FILE #SPR-95-92

TITLE HEADING: Site Plan Review - Additional Residential Unit in RMF-16 Zone (duplex to triplex)

LOCATION: 1815 David Street

PLOT PLAN Rev 6/20/95

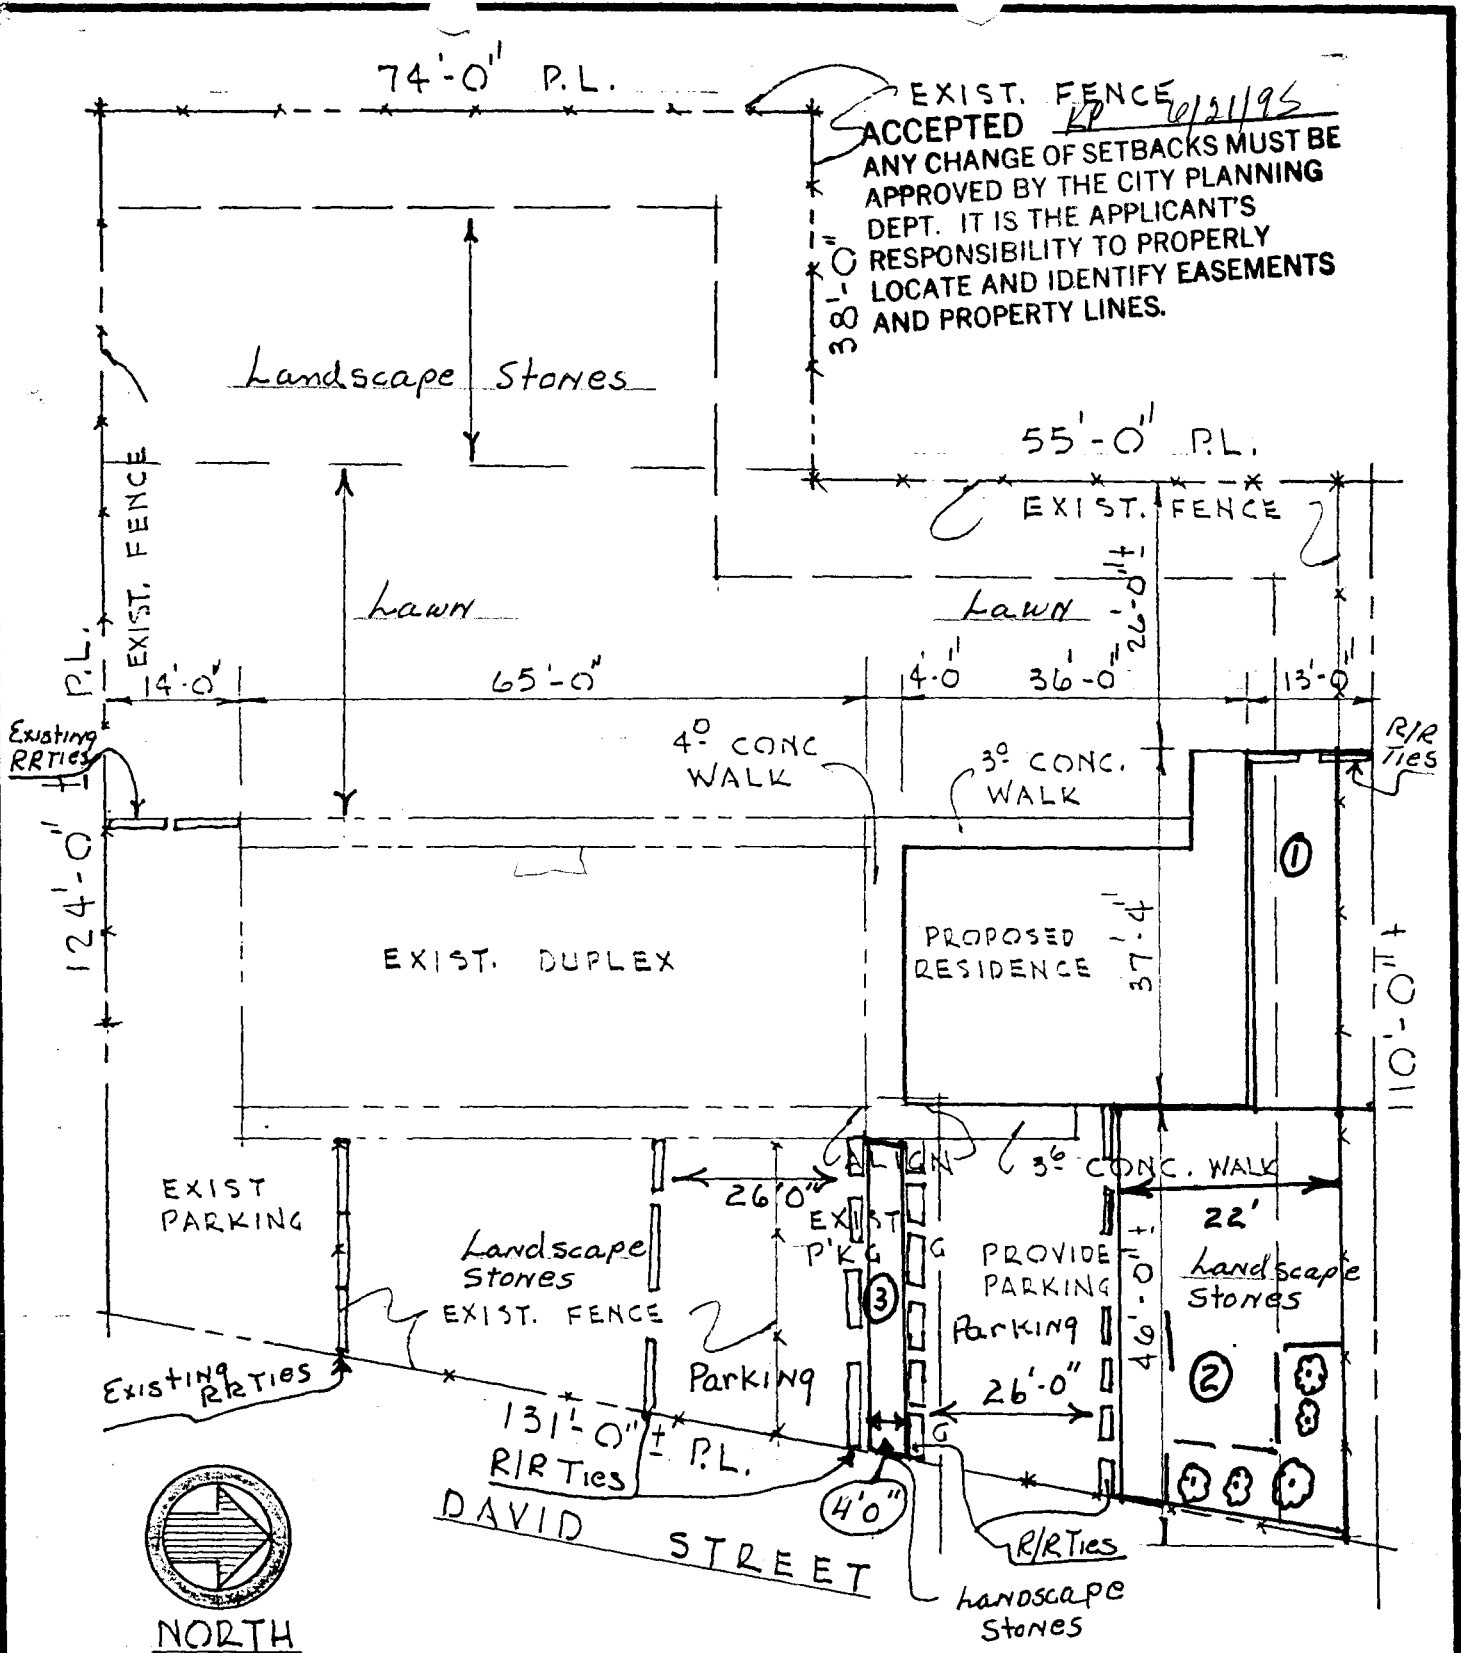
STAFF ANALYSIS: The site is zoned RMF-16. This zone allows multi-family residential development at the density of 16 units per acre. Two off-street parking spaces are required for each unit in a triplex. This requirement is satisfied by the proposal. The petitioner is proposing the front yard to be landscaped with river rock. A more attractive feature would be landscaping with live materials.

- 1) The entire triplex shall maintain at least six (6) off-street parking spaces.
- 2) Landscaping between the designated parking areas should consist of live plants and not stones, river rocks, or similar type materials.
- 3) A Parks and Open Space fee of \$225 is payable prior to or at the time of planning clearance.

LandScape
Adjustment. 6/20/95

B. To be Planted.

$10 \times 22 =$	220 ft^2
$10 \times 10 =$	100 ft^2
	<hr/>
	320 ft^2

C. Trees & Shrubs -

Tree - a) Austrian or } min. 6' planting
 b) Pinyon Pine } height

Each a) Sumac (Quailbush) } min. 5 gal. size
 Spreads 8-10 ft each. or }
 b) Buffaloberry
